Model: LCIT RT5040 (D453)		Date: 21-Aug-09	No.: RD453001
Subject: Service Manual Correction: CIS Image Position Adjustment		Prepared by: M. Abe	
From: PPMC Service Planning Department 1G			
Classification:	<input type="checkbox"/> Troubleshooting <input type="checkbox"/> Mechanical <input type="checkbox"/> Paper path <input type="checkbox"/> Product Safety	<input type="checkbox"/> Part information <input type="checkbox"/> Electrical <input type="checkbox"/> Transmit/receive <input type="checkbox"/> Other (     )	<input type="checkbox"/> Action required <input checked="" type="checkbox"/> Service manual revision <input type="checkbox"/> Retrofit information <input type="checkbox"/> Tier2

Model: LCIT RT5040 (D453)		Date: 14-Dec-2010	No.: RD453002
Subject: New P/N for Tray Indication Decals		Prepared by: K. Tsutsui	
From: PP Service Planning Department 1G			
Classification:	<input type="checkbox"/> Troubleshooting <input type="checkbox"/> Mechanical <input type="checkbox"/> Paper path <input type="checkbox"/> Product Safety	<input checked="" type="checkbox"/> Part information <input type="checkbox"/> Electrical <input type="checkbox"/> Transmit/receive <input type="checkbox"/> Other

## 1.Exterior (D453)

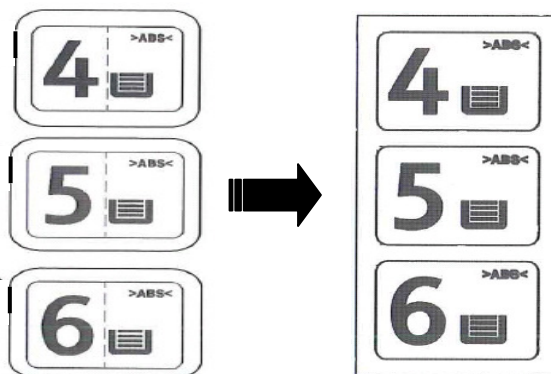
**Change:** Three separate tray indication decals for trays 4, 5, & 6 have been combined.

**Reason:** To reduce production cost

Old P/N	New P/N	Description	Q'ty	Int	Page	Index
D4521312		DECAL:PAPER TRAY:4	1	0/0	2	17
D4521313		DECAL:PAPER TRAY:5	1	0/0	2	18
D4521314		DECAL:PAPER TRAY:6	1	0/0	2	19
	<b>D4521310</b>	DECAL:PAPER TRAY:LCT	1	0/0	2	32

Details > Paper Handling > Paper Separation > “If the air assist fan is used”

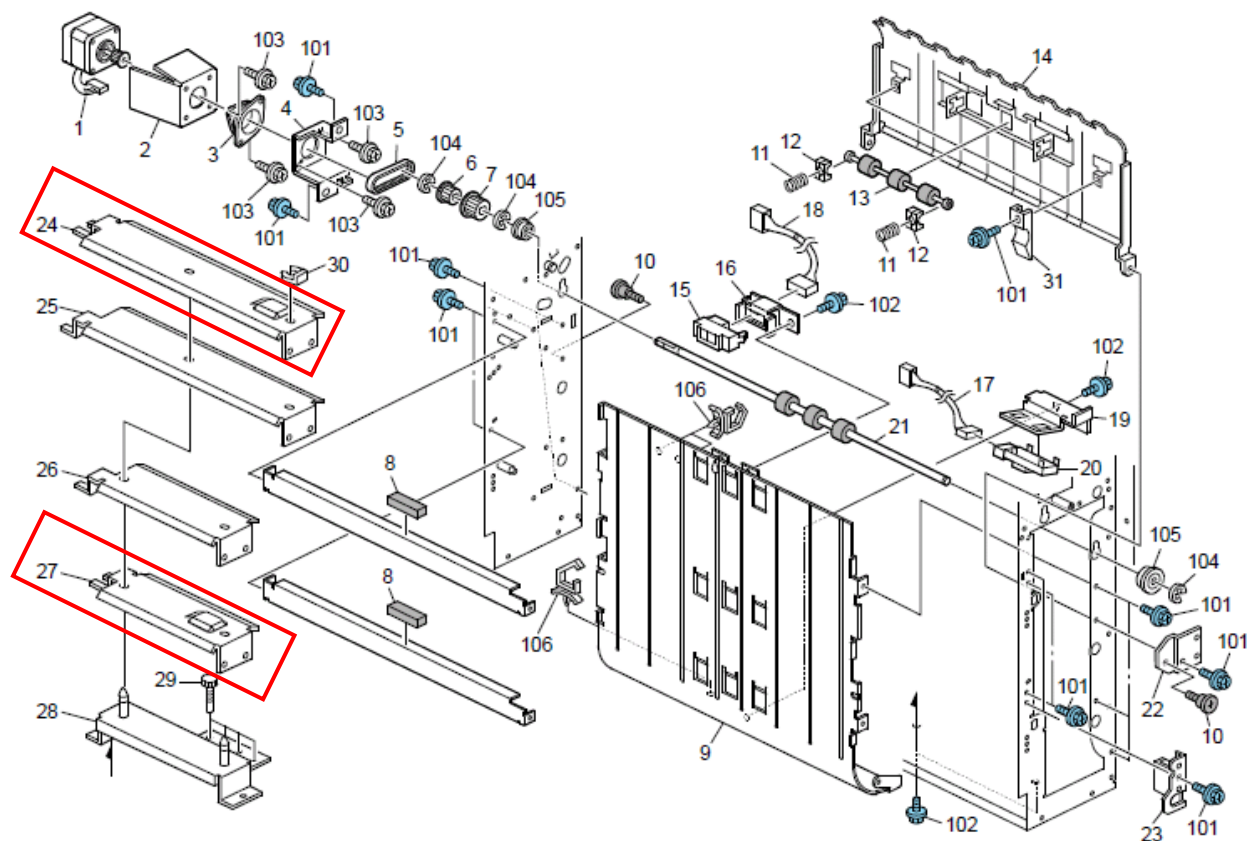
If the air assist fan is used:

- When the grip sensor detects the leading edge of the paper, the paper feed motor switches off and the pick-up roller is still lowered. When the paper feed sensor detects the leading edge of the paper, the pick-up roller lifts and the grip rollers [G] feed the paper out of the tray.

If the air assist fan is used:

When the **paper feed sensor [F]** detects the leading edge of the paper, the paper feed motor switches off and the pick-up roller is still lowered. **Then the feed motor switches on, the paper transport sensor detects the paper, the paper feed motor turns off**, the pick-up roller lifts, and the grip rollers [G] feed the paper out of the tray.

## LCIT RT5040 (D453)

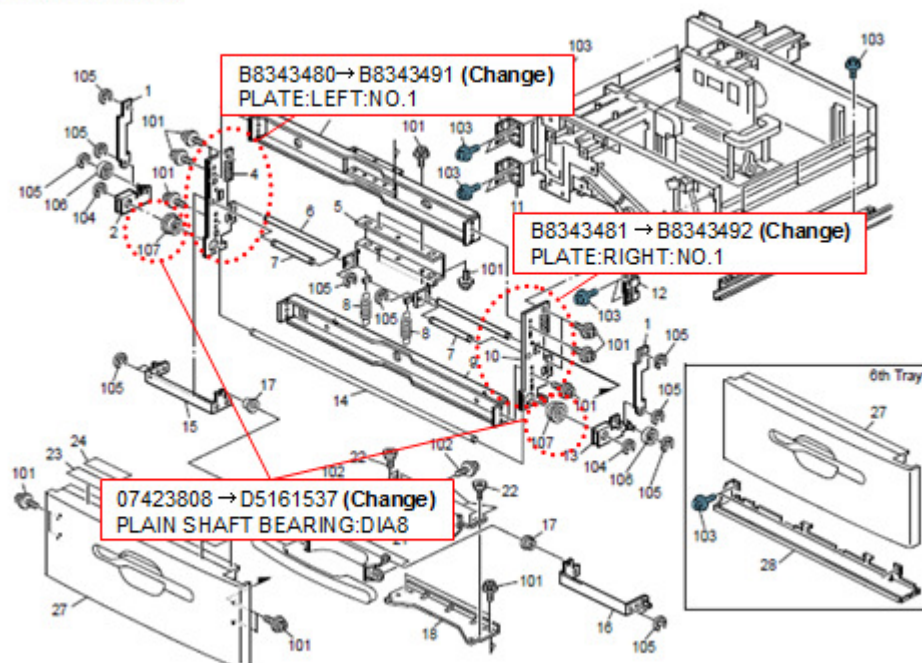
**Change:** Bearing and the shape of the accompanying plates

1, The bearing was changed as shown in the photo below.

2, The size of the holes on the plates were reduced to correspond with the modified bearings.

Old Part Number	New Part Number	Description	Q'ty	Int	Page	Index	Note
07423808	D5161537	PLAIN SHAFT BEARING:DIA8	4	X/O	4 18	107 105	
B8343395	B8343391	PLATE:LEFT:NO.2	1	X/O	18	3	
B8343396	B8343392	PLATE:RIGHT:NO.2	1	X/O	18	11	
B8343480	B8343491	PLATE:LEFT:NO.1	1	X/O	4	4	
B8343481	B8343492	PLATE:RIGHT:NO.1	1	X/O	4	10

- Make sure all 5 parts shown in the above table are replaced as a set.
- The modification described in this bulletin also applies to RT5010 (B834).

**Model: LCIT RT5010 (B834)**

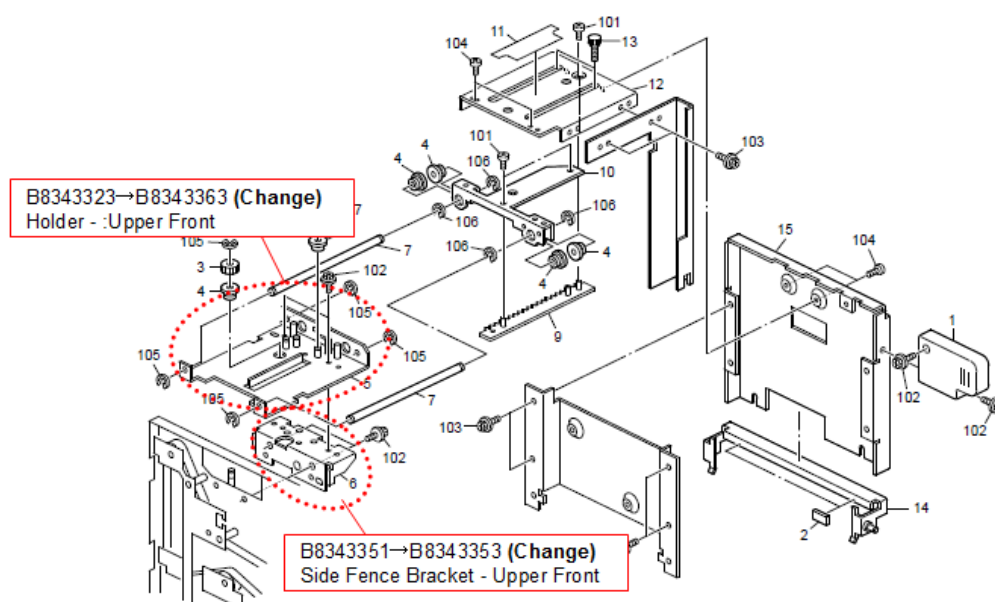
**Change:** Holder and Side fence bracket

**Reason:** To allow usage of common parts for different products

Old Part Number	New Part Number	Description	Q'ty	Int	Page	Index	Note
B8343323	B8343363	Holder - :Upper Front	1	X/X	7	5	A
B8343329	B8343364	Holder - Upper Rear	1	X/X	9	21	A
B8343351	B8343353	Side Fence Bracket - Upper Front	1	X/O	7	6	A
B8343352	B8343354	Side Fence Bracket - Upper Rear	1	X/O	9	19	A

- **When replacing the above parts, replace all 4 parts as a set.**
- **The modification described in this bulletin also applies to Aegis-C1 (D016), LCIT RT4000 (D350), LCIT RT5020 (D355), LCIT RT5040 (D453).**

Changed parts

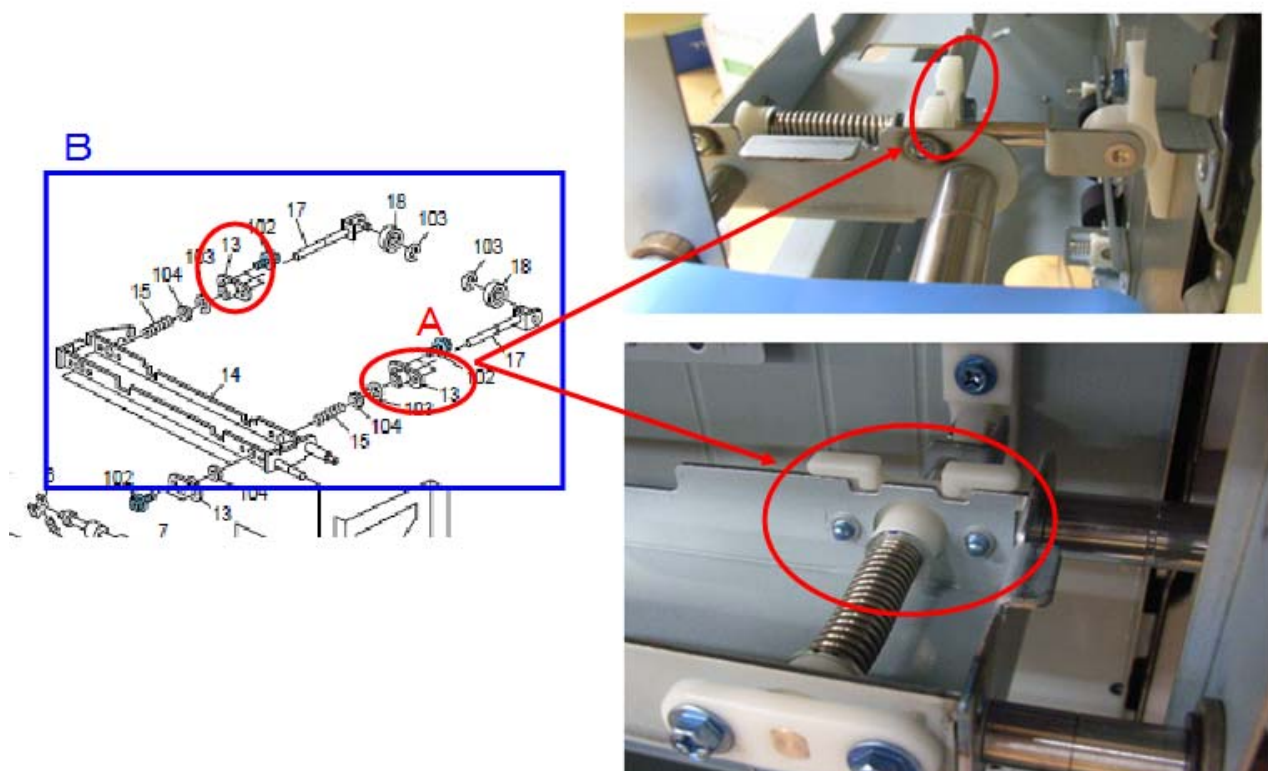
**Change:** Shape of the Handle assembly and Shoe

A : Shoe: Handle: Release

Shape of the Shoe was partially modified.

B : Handle: Ass'y

Handle was also modified in accordance with the shape change of the Shoe.  
(Shape of the plate was also modified.)

8.Tray 4/6 Unit 7 (D453)

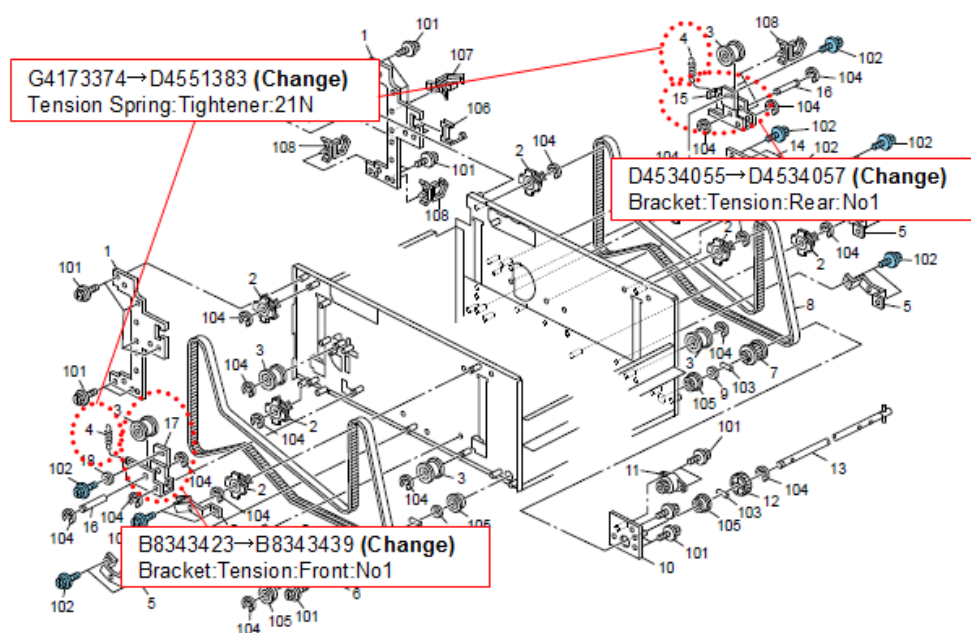
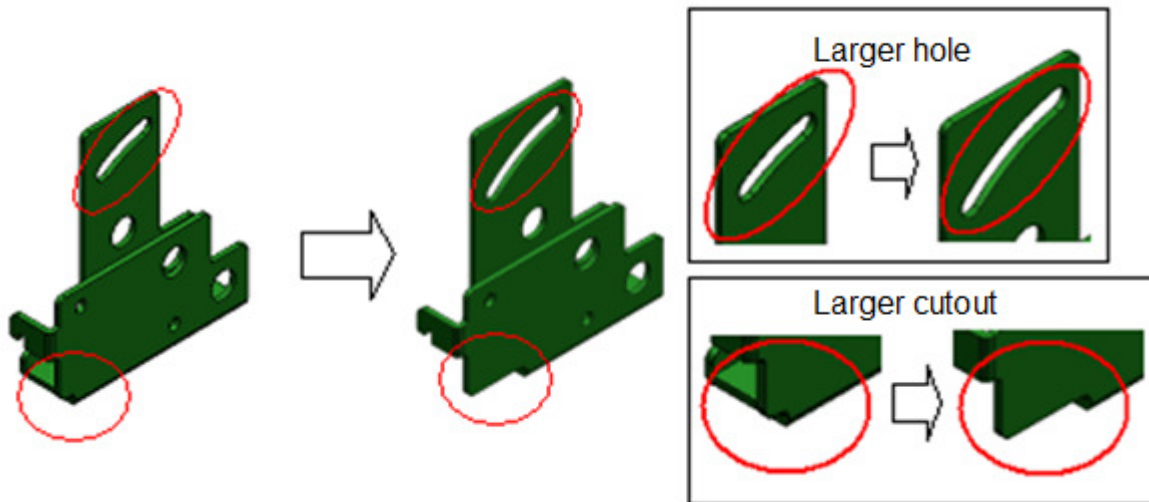
**Change:** Modification 1 - Tension spring of the tray pulley

Modification 2 – Shapes of the tension brackets

**Reason:** To prevent slippage of the pulley which could occur due to the lack of tension applied to the tension springs installed in Tray 4 and Tray 6

***Modification: Tension Bracket***

Old Part Number	New Part Number	Description	Q'ty	Int	Page	Index	Note
G4173374	D5163374	TENSION SPRING: PULLEY: IDLER	4	X/X	17	4	Change
		Tension Spring:Tightener:21N					
B8343423	B8343439	Bracket: Tension:Front:No1	2	X/X	17	17	Change
D4534055	D4534057	Bracket:Tension:Rear:No1	2	X/X	17	15	Change

**NOTE:** When replacing the above parts, replace as a set.

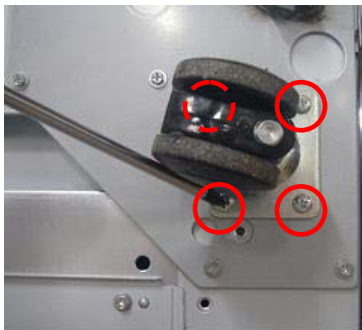
2. Lay the LCT down so that the side to which the mainframe docks faces up.

3. Replace the broken caster with a new one. (Screw x4)

## 14.Tray 5 Unit 6 (D453)

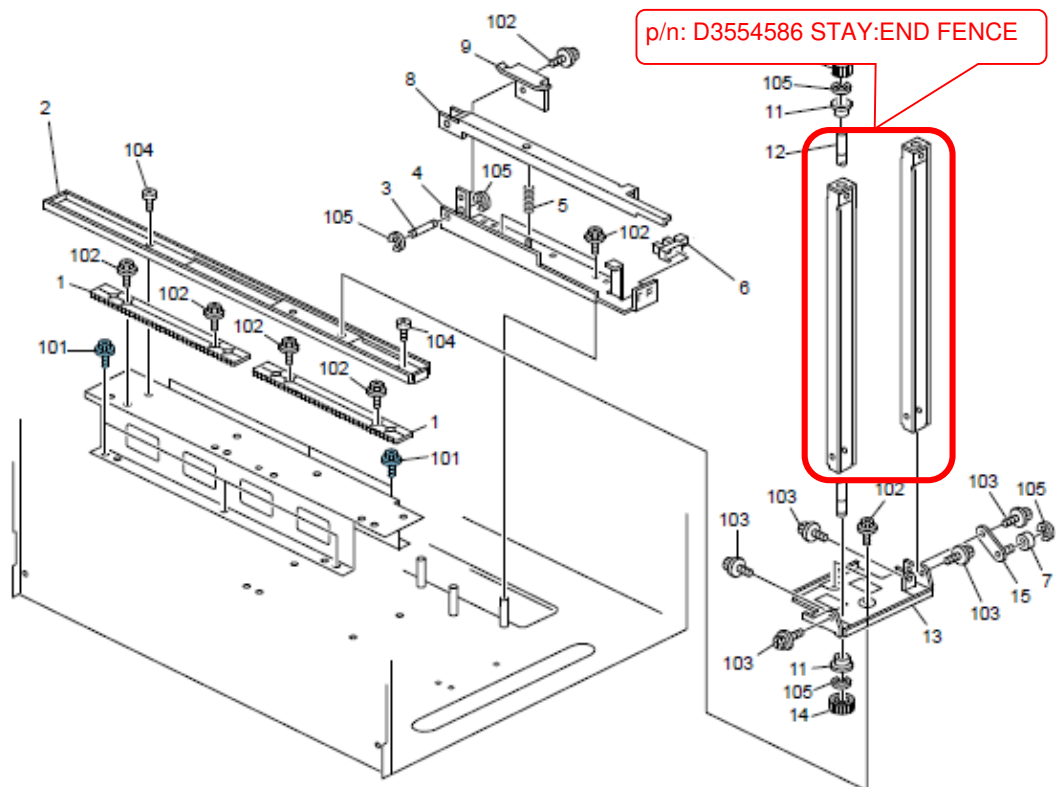
The following part was registered as a service part to meet requests received from the field.

Old p/n	New p/n	Description	Q'ty	Int	Page	Index	Note
-	D3554586	STAY:END FENCE	2	-	171	12	Add

## 17.Paper Feed Unit 1 (D453)

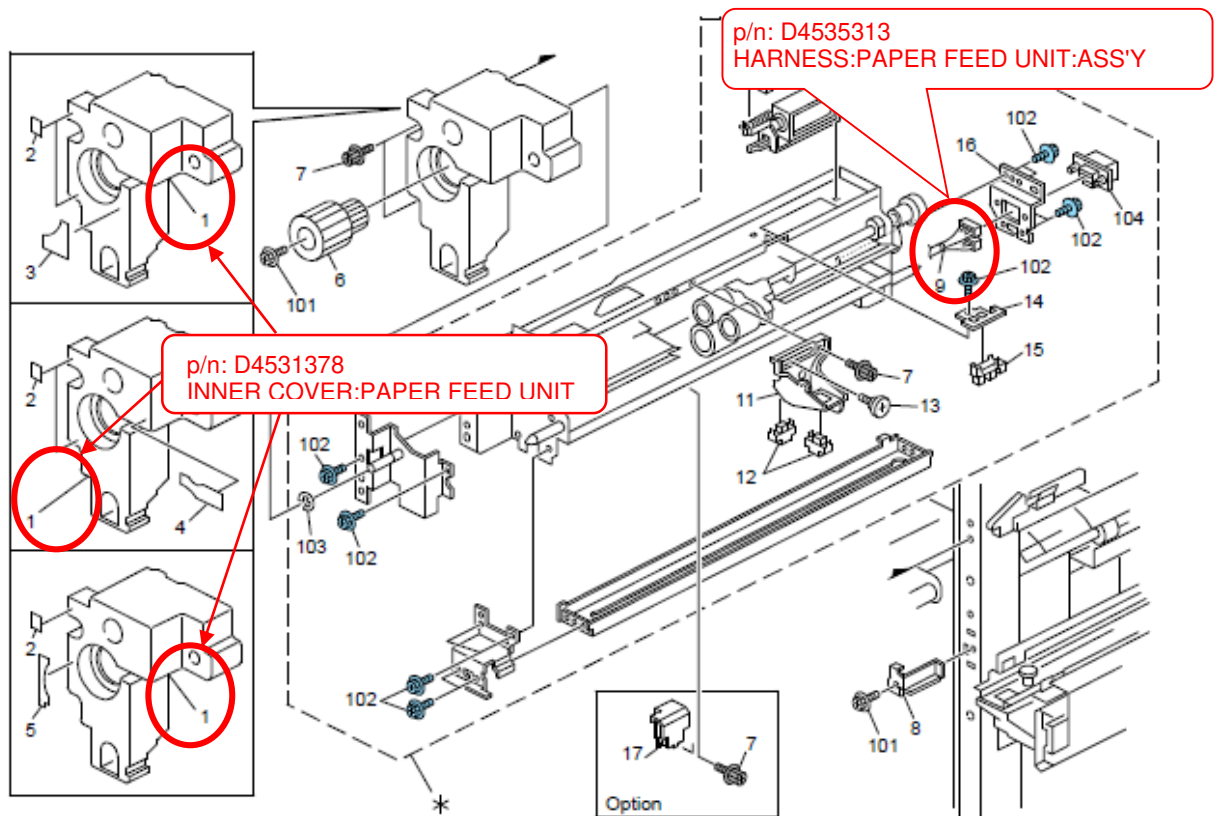
The following parts were modified for easier jam removal.

Old p/n	New p/n	Description	Q'ty	Int	Page	Index	Note
D4535312	D4535313	HARNESS:PAPER FEED UNIT: ASS'Y	3	X/O	35	9	Change
D4531388	D4531378	INNER COVER:PAPER FEED UNIT	3	X/O	35	1	Change
B8322569	B8322579	STAY:FEED:PEEN	3	X/O	37	5	Change
